BELL BEND NUCLEAR POWER PLANT
RESPONSE TO RAI NO. 115 QUESTIONS
09.02.05-18 THROUGH 09.02.05-26, 09.02.05-30
AND 09.02.05-31
BNP-2012-247 Docket No. 52-039

Responses to RAI No. 115,
Questions 09.02.05-18 through 09.02.05-26,
09.02.05-30 and 09.02.05-31

Figure 9.2-7- (Plant Arrangement - ESW/EMB Pumphouse Section C-C)

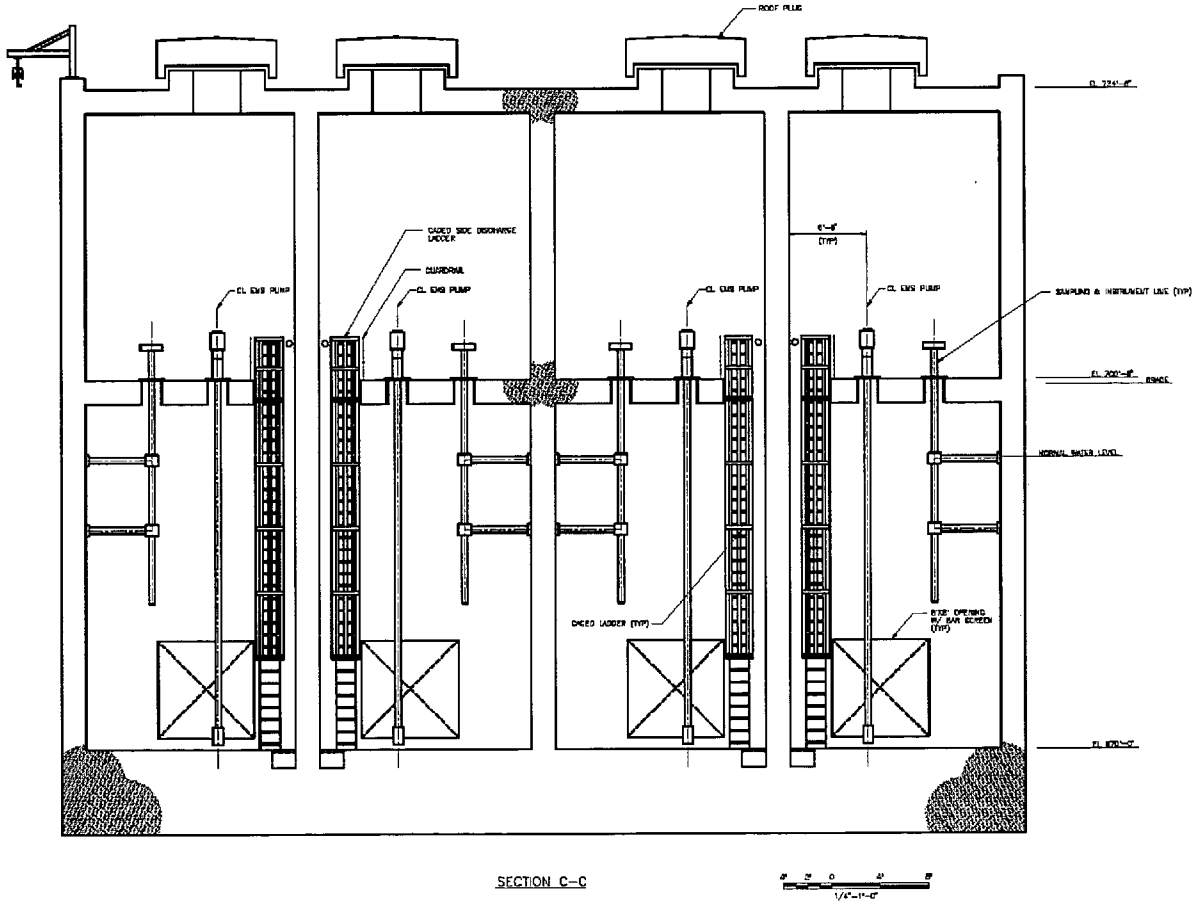
The staff determines that BBNPP FSAR Section 9.2.5 was missing information related to GDC Criterion 44, "Cooling Water" and RG 1.27. BBNPP FSAR Section 9.2.5.3.2 describes the emergency makeup water system (ESWEMS) pumphouse bar screens; however, the staff was unable to locate the bar screens on any FSAR drawings in order to complete its review.

Specifically, the applicant should add this information to the BBNPP FSAR Figures.

ESWEMS Pump House bar screens will be added to FSAR Figures 9.2-5, 9.2-7 and 9.2-8 and Part 3, Environmental Report (ER) Figure 3.4-9 and Figures 9.2-5 and 3.4-9 will be added to Part 9.
